REMEDIAL PLANNING ACTIVITIES
AT SELECTED UNCONTROLLED HAZARDOUS SUBSTANCE DISPOSAL SITES
WITHIN EPA REGIONS I - IV

FINAL RESPONSIVENESS SUMMARY
OLD SPRINGFIELD LANDFILL SITE
SPRINGFIELD, VERMONT

SEPTEMBER 1988

Exhibit 1
**Old Springfield Landfill Site
Area of Proposed Cap**

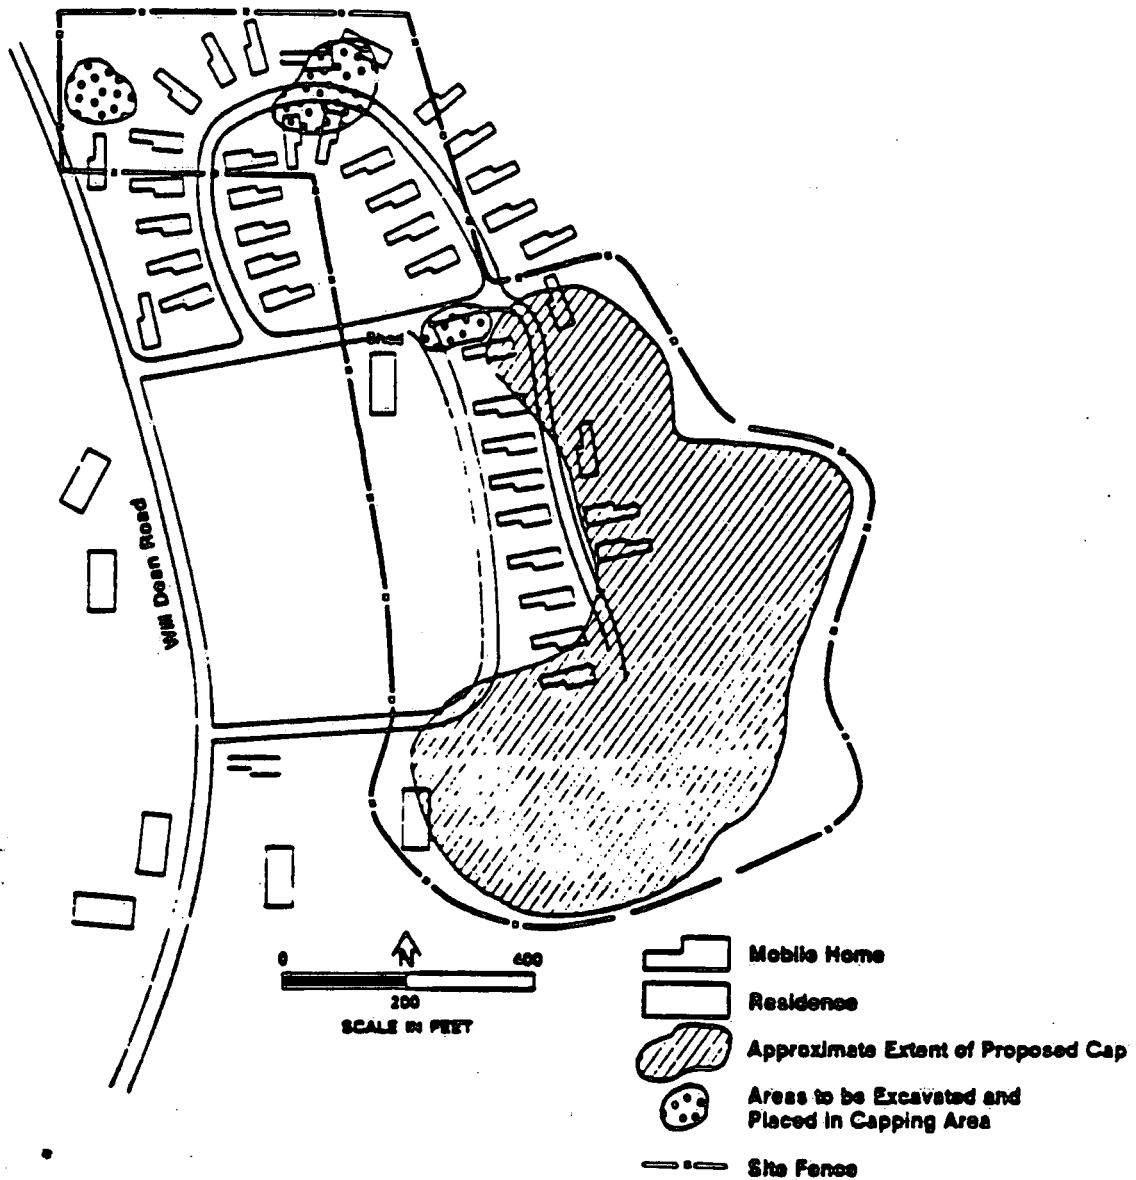
- h) Residents asked that the proposed fence around the site enclose the capped area only and not excavated areas north of the cap

(See Exhibit 1). Residents also requested that warning signs be posted along the fence at access points only.

See response to citizen comment A.1.a. above.
